# Access Compliance Report

## Public Rights-of-Way

### (Curb Ramps)

Intersection ID: 28611	Main Street: FALCONCREST_DR	Cross Street: KESTRAL_RIDGE_DR	Location:	S
ADA ID: F384926AA2F6	Ramp Type: BlendTrans1	Initial Pass/Fail: Fail	Overall Compliance: No	Severity Score: 10
Codes/Mitigation Info/Possible Solution		Field Measurements/Component Compliance

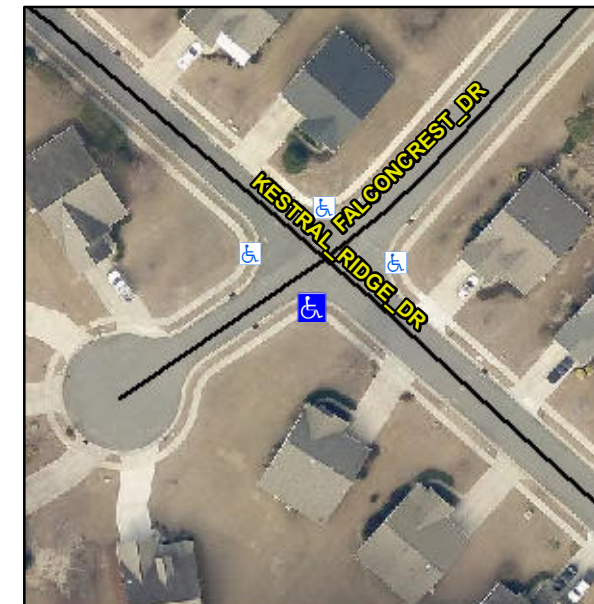
Compliance	Description	Data	Compliance	Description	Data
N/A	Ramp Length (in)	48.0	Yes	BlendTrans Slope (%)	4.6
No	Ramp Width (in)	43.0	No	BlendTrans XSlope (%)	2.8
N/A	Flare Type LT	N/A	N/A	Flare Type RT	N/A
N/A	Flare Slope LT (%)	N/A	N/A	Flare Slope RT (%)	N/A
N/A	Flare Traversable LT?	N/A	N/A	Flare Traversable RT?	N/A
N/A	Landing Length (in)	N/A	N/A	DWS Provided?	N/A
N/A	Landing Width (in)	N/A	N/A	DWS Contrast?	N/A
N/A	Landing Slope (%)	N/A	N/A	DWS Length (in)	N/A
N/A	Landing X Slope (%)	N/A	N/A	DWS Full Width?	N/A
N/A	Landing Curb? (Y/N)	N/A	N/A	DWS Offset (in)	N/A
N/A	Shared Landing?	N/A			
N/A	Gutter Ponding?	N/A	N/A	Gutter Slope (%)	N/A
N/A	Gutter Lip Ht (in)	N/A	N/A	Gutter X Slope (%)	N/A
N/A	Painted X Walk1?	No	N/A	Painted X Walk2?	No
	X Walk 1 Direction	To NE		X Walk 2 Direction	To NW
	X Walk 1 Width (in)	N/A		X Walk 2 Width (in)	N/A
	X Walk 1 Slope (%)	2.2		X Walk 2 Slope (%)	0.1
	X Walk 1 X Slope (%)	1.0		X Walk 2 X Slope (%)	2.3

N/A	Ramp inside XWalk1?	N/A	N/A	Ramp inside XWalk2?	N/A
	Road Slope (%)	1.7		Clear Space?	N/A
	Road X Slope (%)	2.6	N/A	Clear Space to XWalk (in)	N/A
N/A	Any Obstructions?	N/A	N/A	Storm Grate/Utility Hazard?	N/A
	Obstruction Type			Storm Grate/Utility Type	
		N/A			N/A
			Yes	Surface Condition? (G/P)	Good
			N/A	Curb Slope (%)	3.3

**Remove & Replace Curb Ramp With Two New Directional Ramps or Equivalent.**

**R304.5.1, R304.5.3**
